SERVICE ACTION: RETROFITTING REAR AXLE GROUND STRAP FOR RADIO INTERFERENCE

G12 (7 Series PHEV)

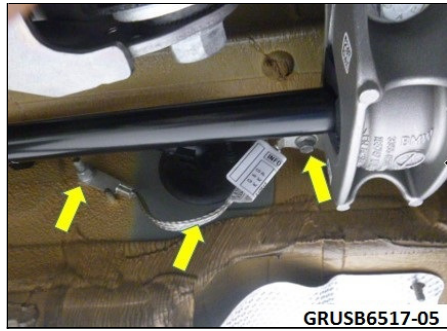
Retrofit the ground cable from the rear axle to the body.

1. Raise vehicle on lift.
2. Install ground cable from the rear axle to the body where shown below.

Torque nut and bolt both to 12 Nm.
